**Re: Review of B2Gold Nunavut's 2024 Annual report for Back River  
Project Certificate NIRB No. 007.**

Dear Keith Morrison, the KIA has reviewed B2Gold Nunavut's 2023 Annual Report for the Back River Project Certificate NIRB No. 007.

**Figure 4.5-5 Bathurst Inlet 2024 Monthly Total Precipitation Summary (TC8-5)**

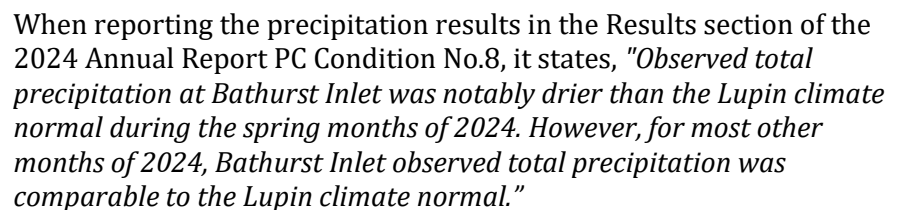
<b>Subject/Topic</b>	Omissions/errors in climate and meteorology results. PC Condition No. 8
<b>References</b>	B2B Gold, Back River Project, 2024 Annual Report (April 4, 2025) <ul style="list-style-type: none"> <li>PC Condition No. 8</li> </ul>
<b>Summary</b>	<p>The onset of freeze-thaw cycles and the highlight of any extreme or outlying weather events were omitted from the PC Condition No. 8 section of the 2024 Annual Report.</p> <p>There were minor errors when reporting the average monthly temperature and precipitation results in the 2024 Annual Report PC Condition No. 8 Results section.</p>
<b>Detailed Review Comment</b>	<p>The Term or Condition section of PC Condition No. 8 states, “The Proponent shall provide a summary report of meteorological conditions experienced within the project area including details related to temperature, wind velocities and patterns, precipitation, as well the onset of seasonal freeze and thaw cycles and highlight extreme or outlying weather events.” The 2024 Annual Report presented results for most of these parameters; however, no data were included for freeze-thaw cycles or extreme or outlying weather events. There is no mention of freeze-thaw cycles in the AQMMP (2019) or how those events will be measured (e.g., ice on/off a waterbody, freezing or thawing of permafrost, temperature threshold).</p> <p>Even if there are no extreme or outlying weather events during the year, this should be clearly stated in the Annual Report so there is no confusion about whether this is an omission or if there is no data to provide.</p> <p>The Results section of the 2024 Annual Report PC Condition No.8 states, “Figure 4.5-1 presents the monthly mean temperatures observed at the Goose station and Bathurst Inlet in 2 compared to the 1991-2020 Lupin Composite station climate normal. Average monthly temperatures recorded at the Goose Lake station in 2024 were warmer than the climate normal averages from Lupin for all months except for January, March and June.”</p> <p>However, in the corresponding figure, the Goose Lake average temperature in 2024 is also warmer than the climate average normal for Lupin. This text should be revised to read that “<i>Average monthly temperatures recorded at the Goose Lake station in 2024 were warmer than the climate normal averages from Lupin for all months except for January and March</i>”.</p>

- Please provide data on freeze-thaw cycles and any extreme or outlying weather events (or state that no events occurred in the results section of 2024 Annual Report PC Condition No.8.
- Update the AQMMP (2019) to include the type of data and where and when they are recorded to measure freeze-thaw cycles for PC Condition No. 8
- Please revise the Results section of the 2024 Annual Report

<p>PC Condition No.8 to indicate that Average monthly temperatures recorded at the Goose Lake station in 2024 were warmer than the climate normal averages from Lupin for all months except for January and March.</p> <ul style="list-style-type: none"> <li>Please revise the precipitation Results section of the 2024 Annual Report PC Condition No.8 to indicate that the total precipitation observed at Bathurst Inlet was notably drier than the Lupin climate normal during the spring months and in August of 2024.</li> </ul>
<b>Agree or Disagree with Compliance Statement</b>	We disagree with B2B Gold's assessment of compliance with this condition. The 2024 annual report omits freeze-thaw cycle data, so B2B Gold is partially compliant.
<b>Importance</b>	High
